4th February 2019
Our ref: 1030_EGOVR:GM

**Re: Rix's Creek Continuation Project, Response to Recommendations –
Request for additional information from the Department of Planning and
Environment**

Rix's Creek Continuation Project
RCCP overburden option assessment -
biodiversity
Figure 1

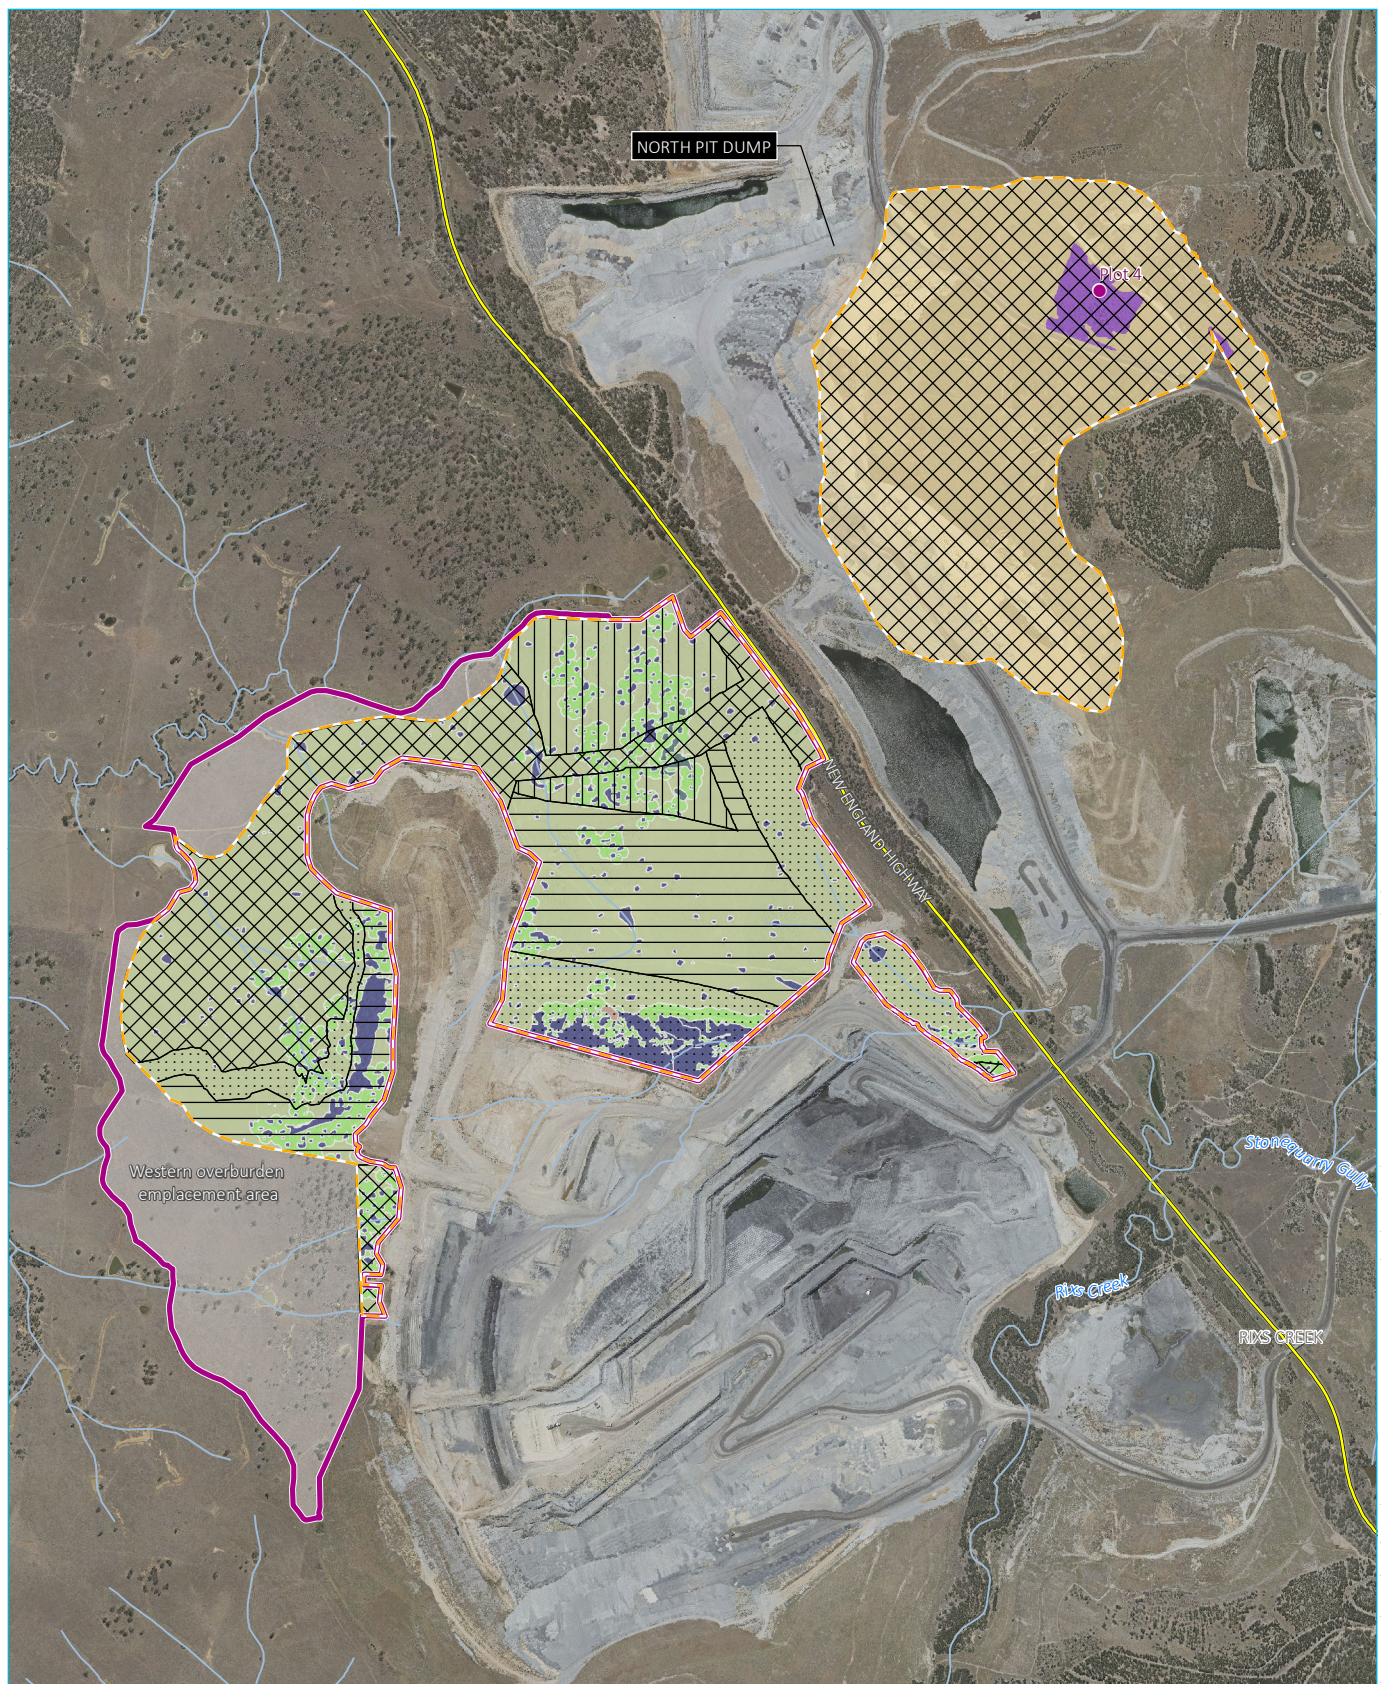
Having regard to page 50 of your response and the commitment to secure all required offsets within three years of the consent being granted, I wish to flag that the Department has concerns with this proposal. As discussed in section 6.5.5 of the Department's preliminary assessment report, offsets should be secured prior to disturbance or (at worse) soon after (<18 months). The latter would be acceptable if land-based offsets have been identified but additional time is required to secure them. We appreciate that this can be quite a substantive upfront obligation so the alternative is to undertake disturbance/offsetting in stages. Please reconsider your offsetting proposal in light of this advice. Happy to discuss further.

EMM have identified the credits required to offset against actual disturbance for Option 2 at years 2020, 2023, 2026 and 2029. The credits associated with disturbance at these years is presented in Table 3.1 of the report, attached to this letter, dated 15 January 2019 from EMM (H180448_RCCP_staged offsets_V1). (Attachment 1).

The four proposed stages of the RCCP are detailed in Figure 1. The area of each vegetation zone impacted during each stage and the corresponding offset obligations are provided in Table 3.1.

Figure 1: Comparison of incremental 24-hour average PM_{2.5} concentrations ($\mu\text{g}/\text{m}^3$)

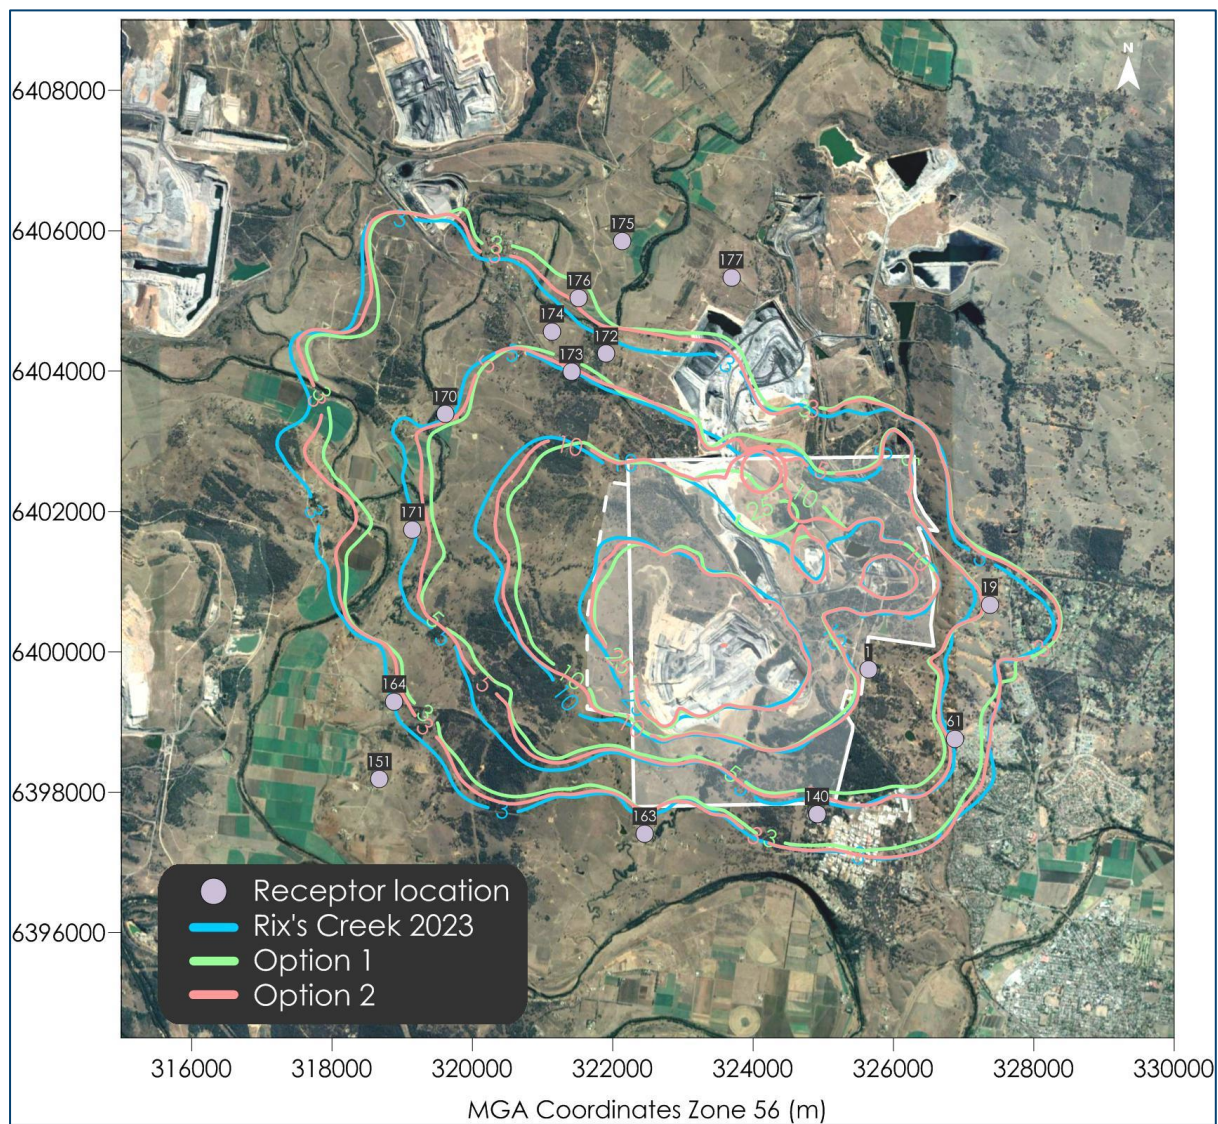
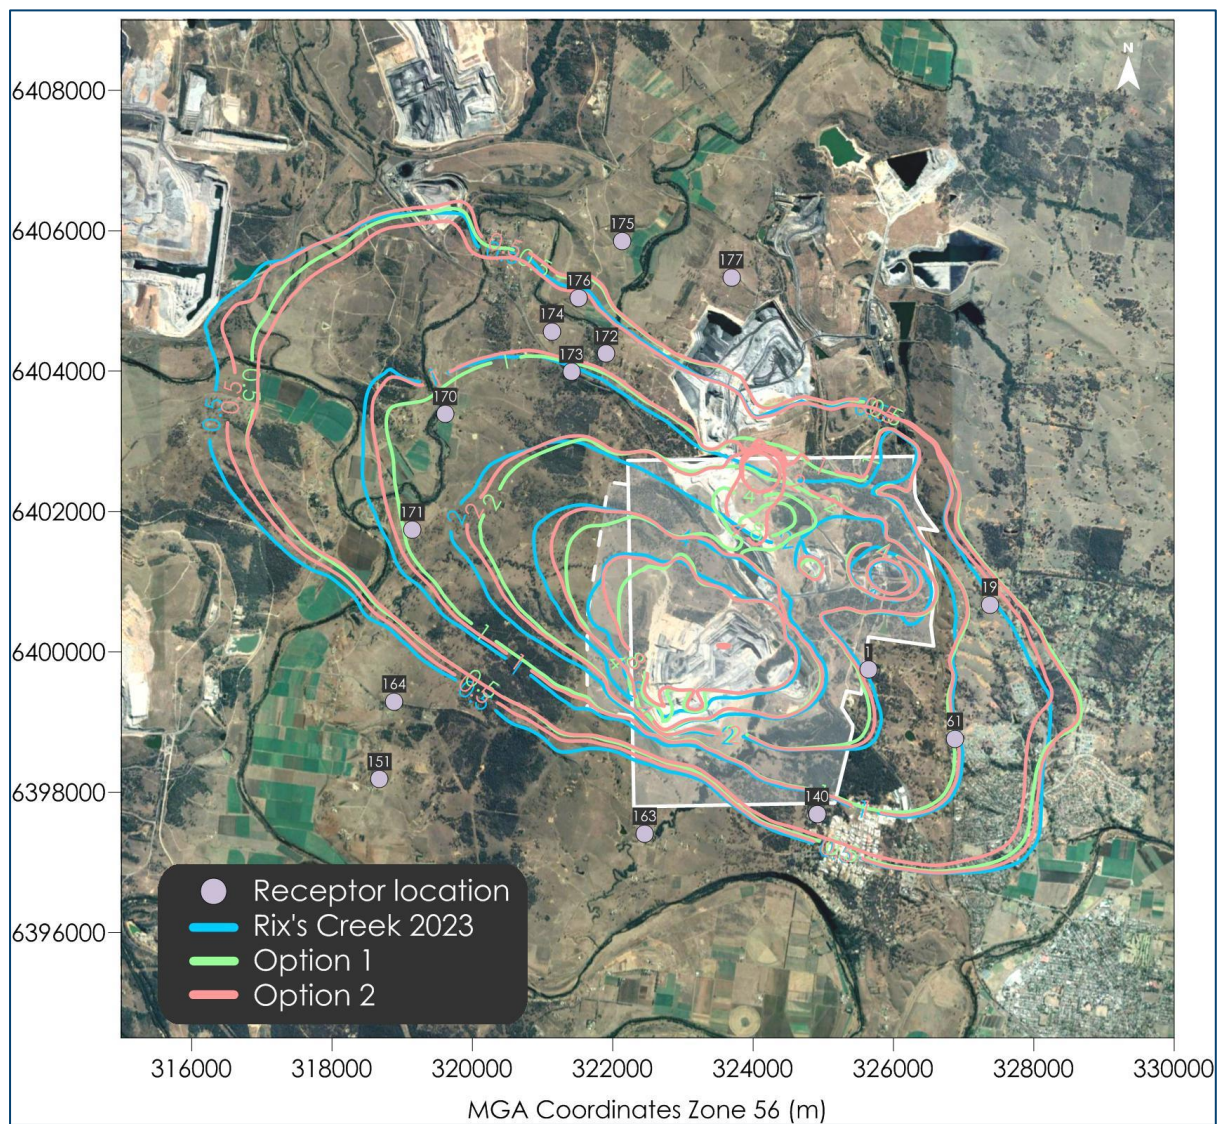
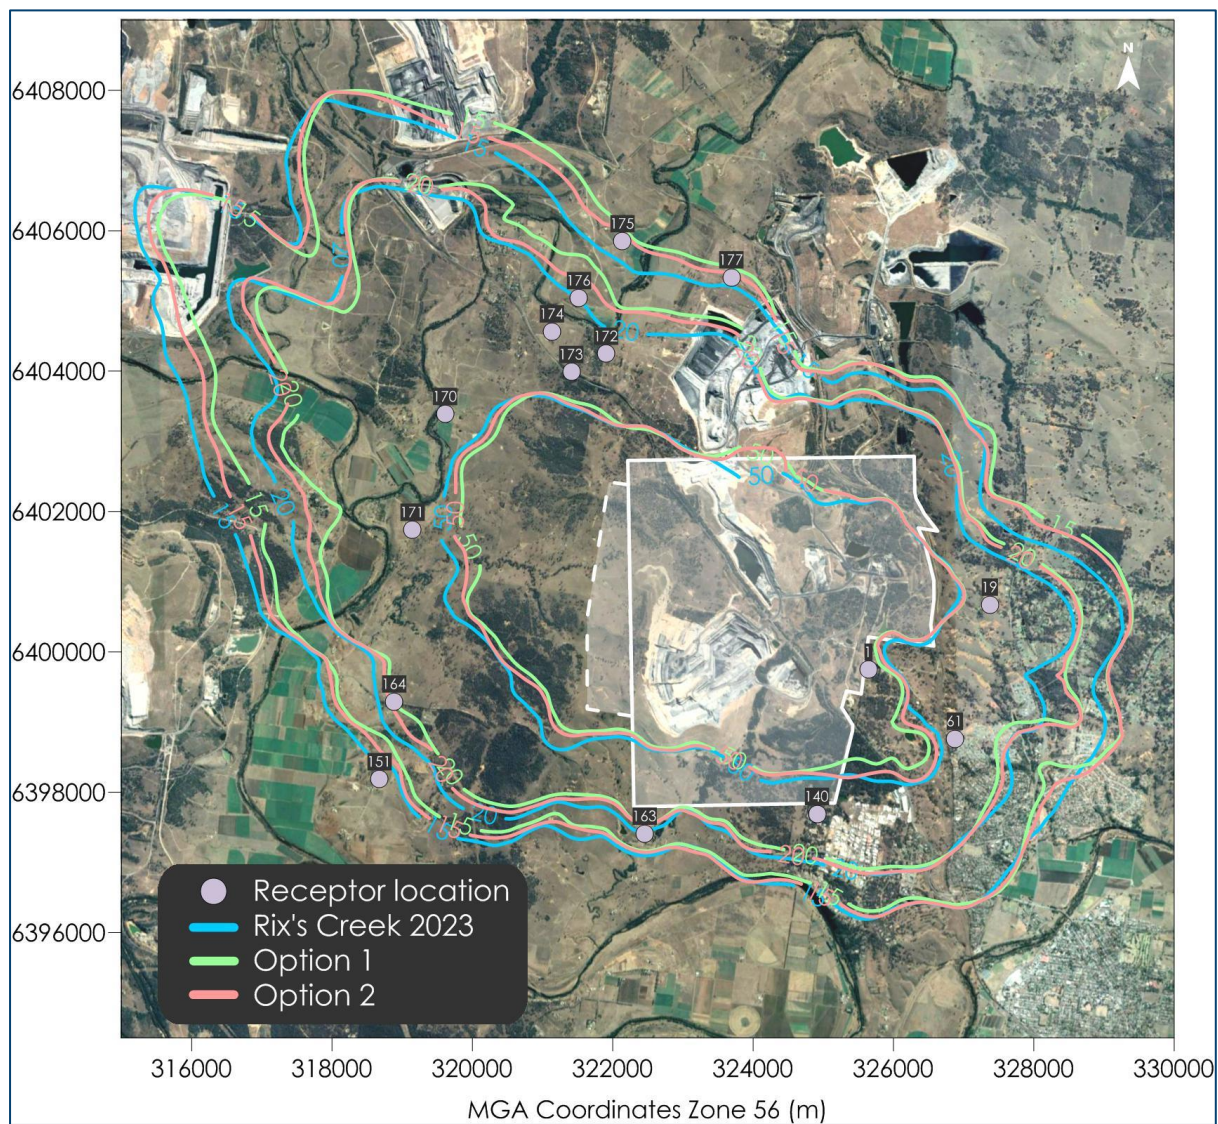
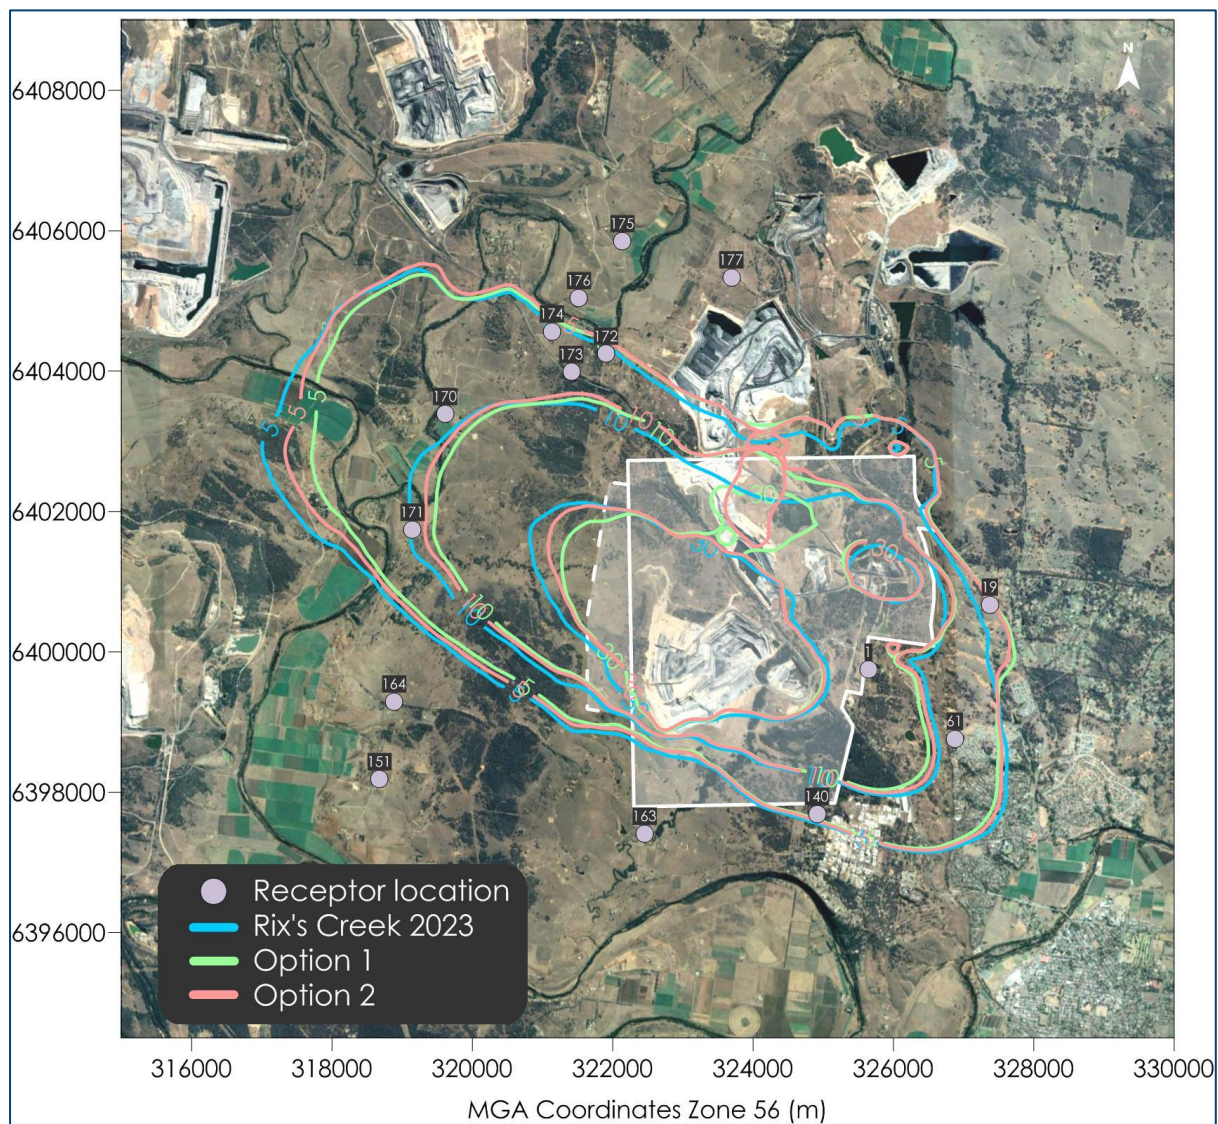
It is noted that section 2.5.2.1 and Appendix F of your response indicates that the air quality impacts would only minimally change under the preferred option 2. The contour maps are helpful, however we would like to have a closer look at the changes at a receiver level. Can you please provide revised air quality predictions or a representative sample of them. At a minimum I would like to see the revised predictions for all receivers where an exceedance of criteria was previously predicted.

Todoroski Air Sciences have prepared a document dated 3 January 2019, which is attached to this letter. (Attachment 2). The document provides a selection of receptor results presented in table form and showing the location of the receptors on the contour plans. The receptors presented in the attached report are

- Receptors 1, 170 to 177 inclusive, are those that had previously been predicted to experience impacts as per Table 9-11 of the AQIA
- Receptors 19, 61, 140, 151, 163, 164 are the nearest receptors covering the area around the mine not covered by the receptors listed above

Figure 1 to **Figure 4** present the dispersion modelling results comparing the predicted incremental 24-hour average $PM_{2.5}$, annual average $PM_{2.5}$, 24-hour average PM_{10} and annual average PM_{10} with the location of the selected receptor locations shown.

FIGURE 1-1

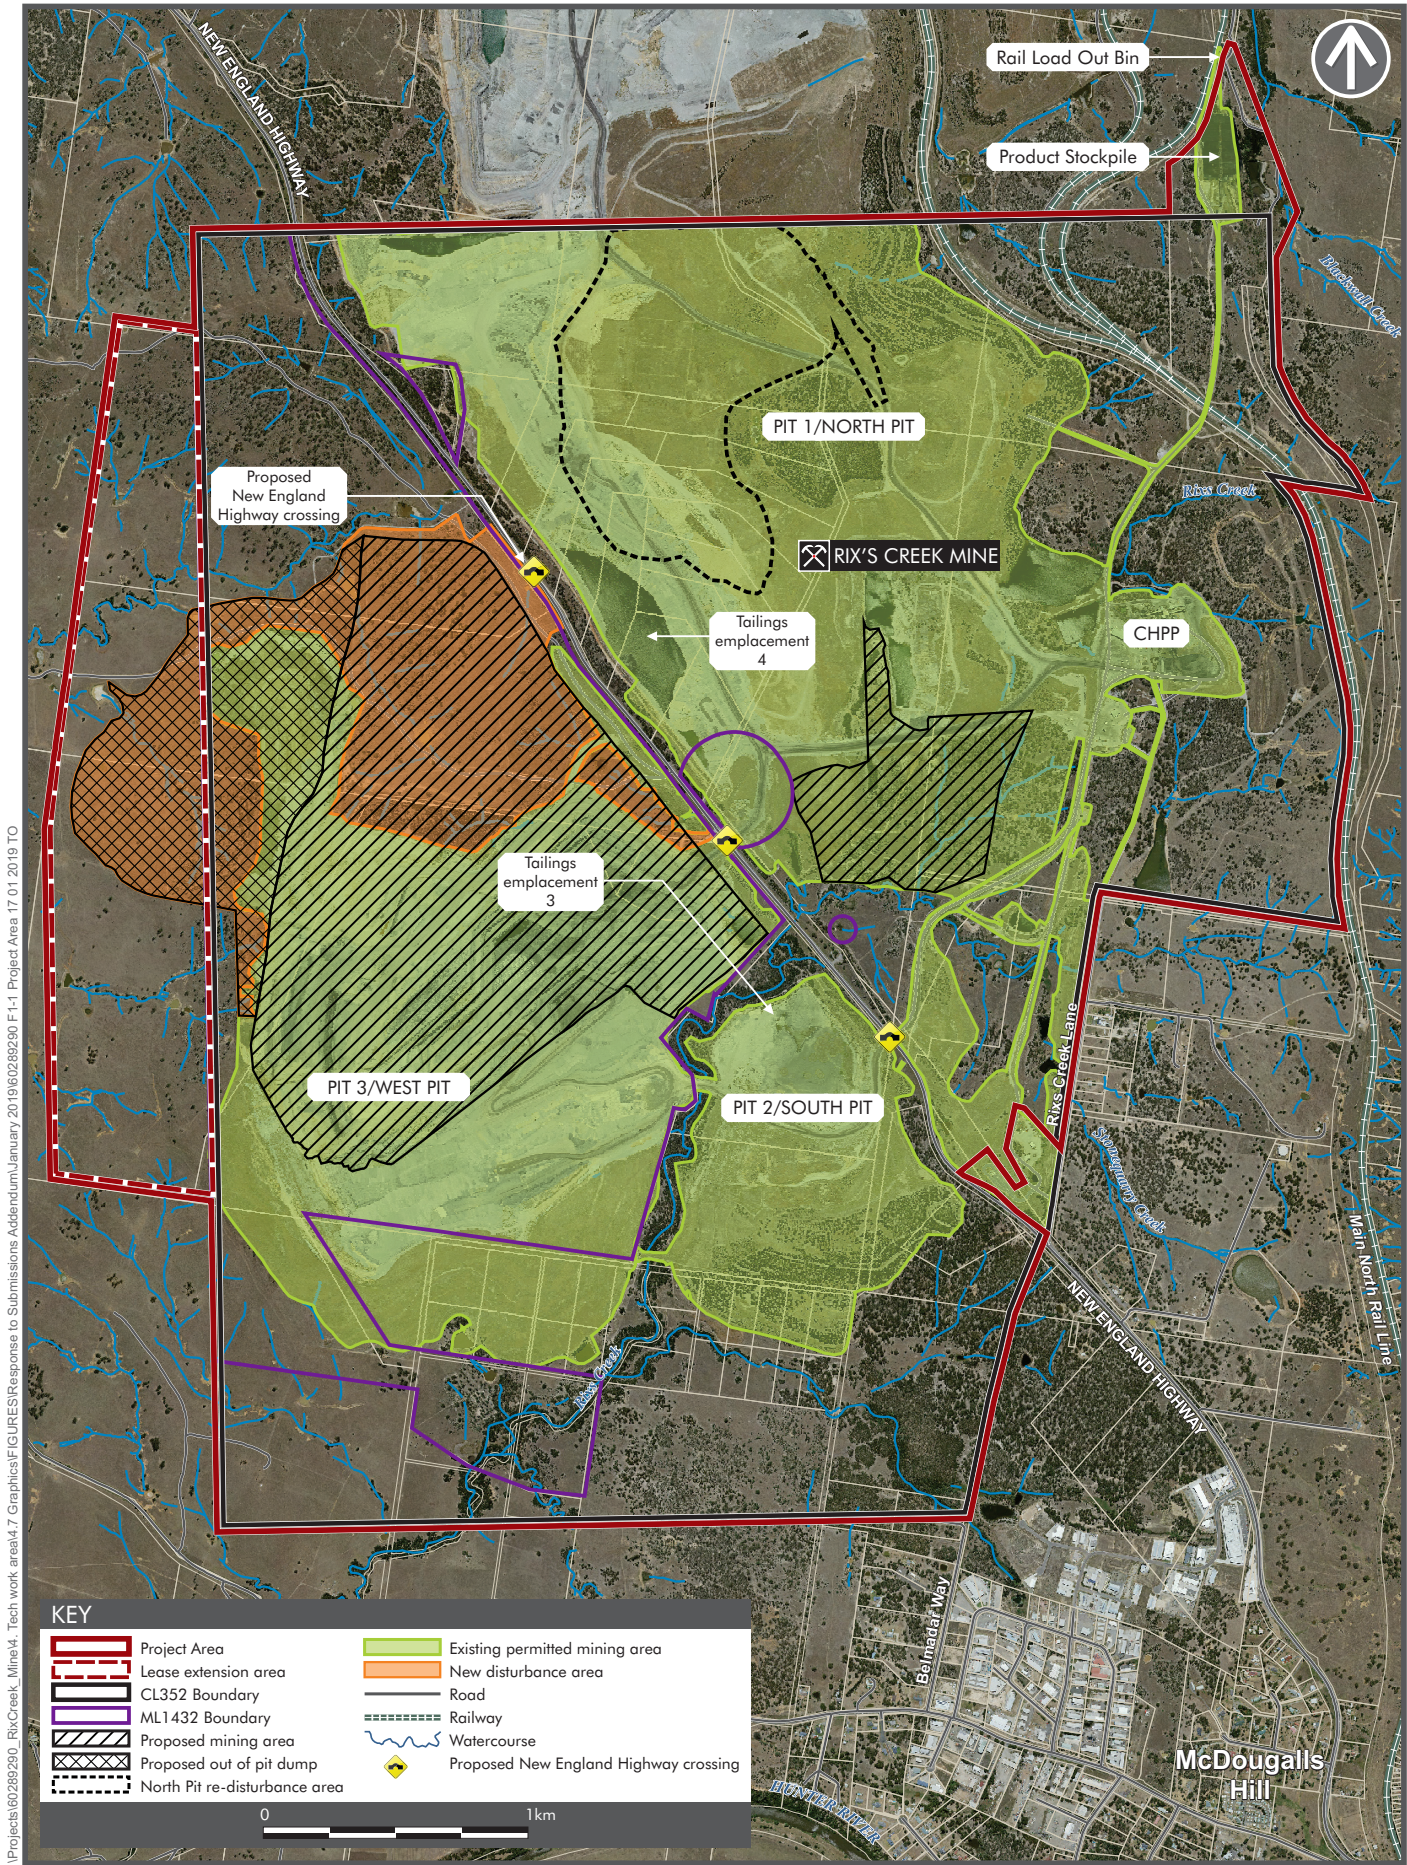
Please provide an updated development layout figure based on option 2. All key surface features should be shown and labelled, such as the disturbance boundaries, pits, OEAs, tailings storages, cut and cover tunnels, etc.

Please see a copy of the updated plans attached to this letter as Project Area – Option 2 Figure 1-1, (Attachment 3) and Final Landform – Option 2 Figure 1-2. (Attachment 4).
